SUBJECT: NEW VEHICLE DEMONSTRATION/DELIVERY HOLD - Compliance Recall 18C04
Certain 2018 Model Year EcoSport Vehicles
Brake Fluid Reservoir Cap and Owner's Manual Kit Replacement

NEW VEHICLE DEMONSTRATION/DELIVERY HOLD - Compliance Recall 18C04

CERTAIN 2018 MODEL YEAR ECOSPORT - BRAKE FLUID RESERVOIR CAP AND OWNER'S MANUAL KIT REPLACEMENT

FIGURE 1

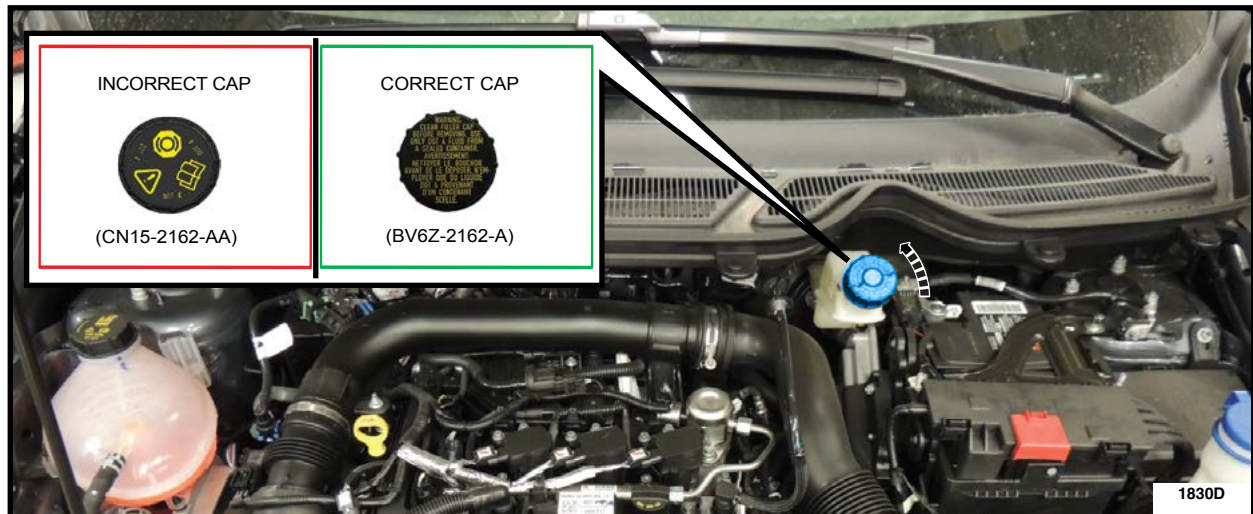
1. Remove the brake fluid reservoir cap and discard. See Figure 1.

FIGURE 2

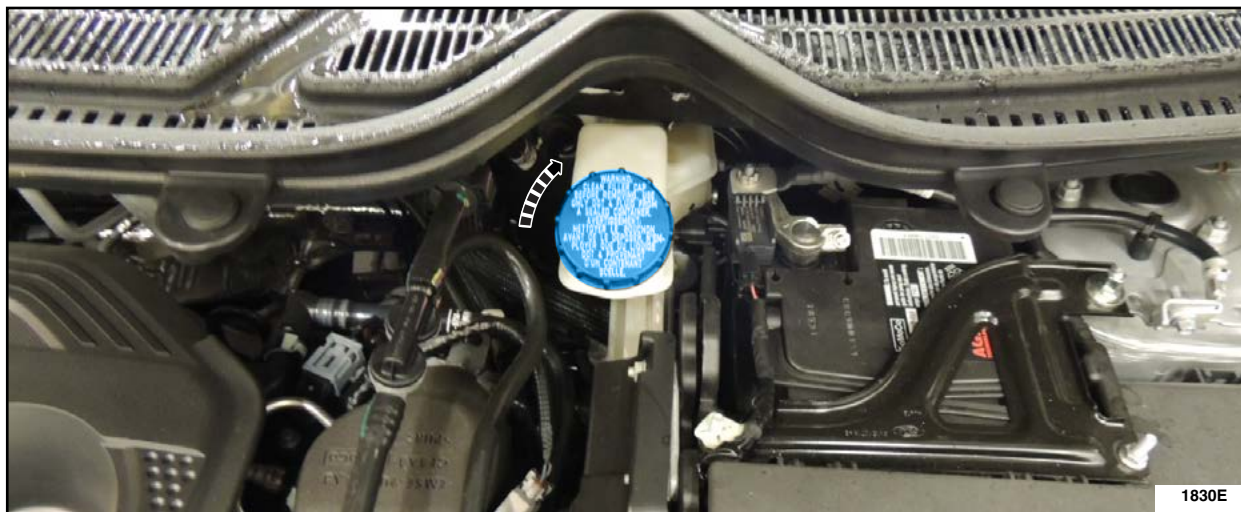
2. Install the new brake fluid reservoir cap. See Figure 2.

- Part must be assembled clean and installed securely to brake fluid reservoir.
